PERMIT

Permit Number: 091221

has permission to Enclose existing Porch

AT 16 CITY VIEW RD PEAKS ISLAND CBL 087 00007001

PLAN
1/4" = 1'-0"

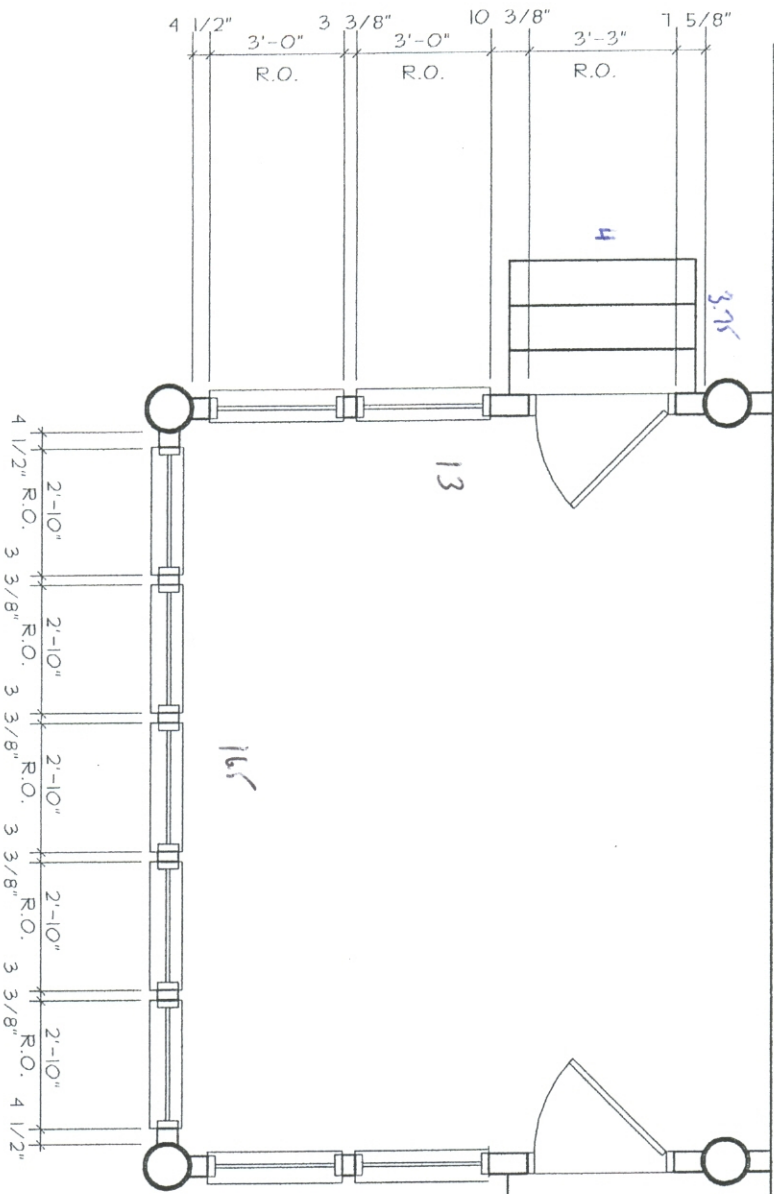
Dept: Zoning	Status: Approved with Conditions	Reviewer: Ann Machado	Approval Date: 11/05/2009
Note: 16 City View Rd used to be 14 Centenial St. Rear Rear covered porch was permitted under #98-0278. Stairs are adding 33.69 sf & 15 sf which is still under lot coverage. Stairs on right side encroach on side yard setback, but OK under section 14-425.			Ok to Issue: <input checked="" type="checkbox"/>

EXTERIOR ELEVATIONS

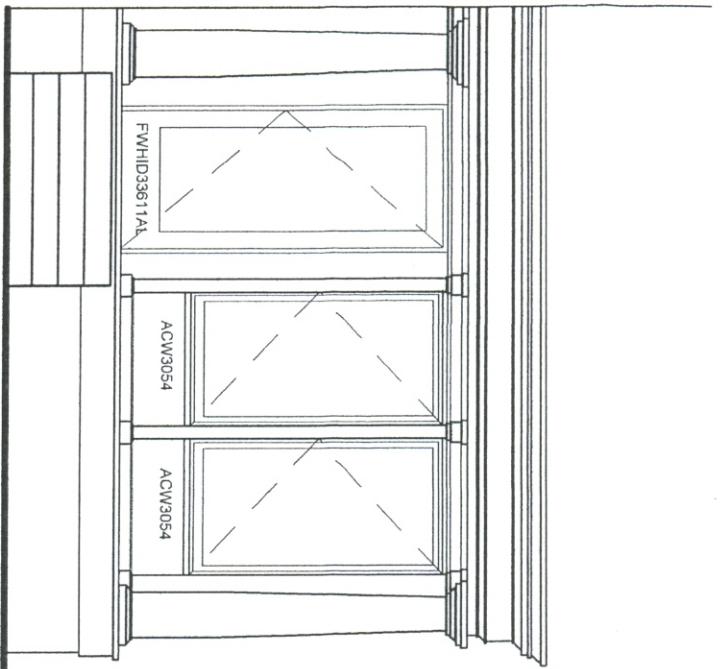
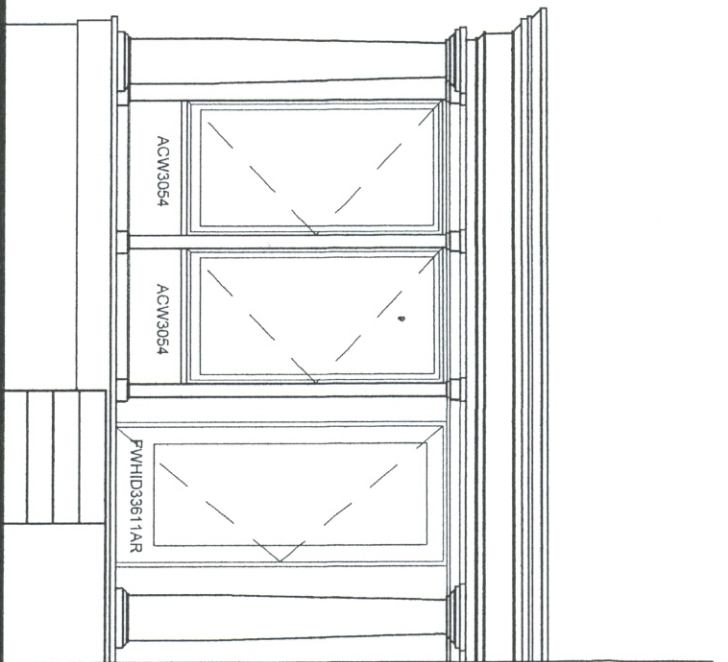
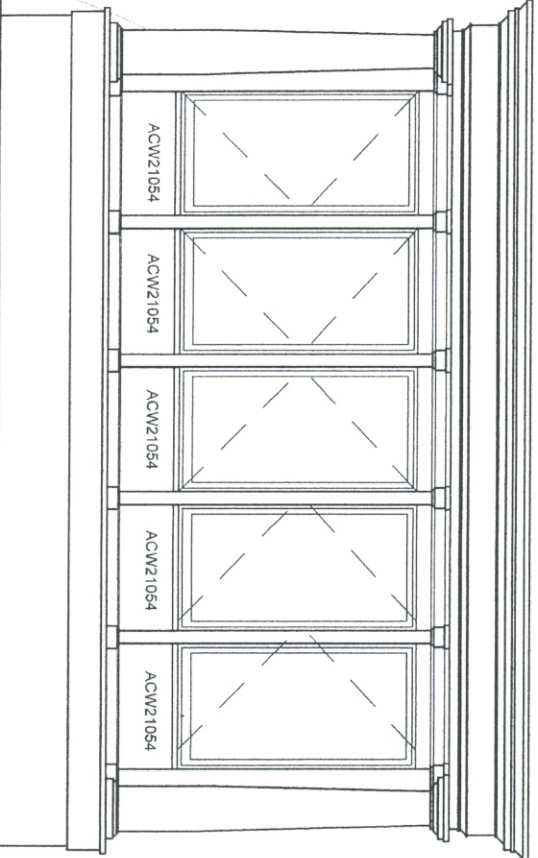
Comments: 11/9/2009-tm: called contractor Bill Bunton and requested info on window framing including headers.

2x4 wall framing
2x6 headers
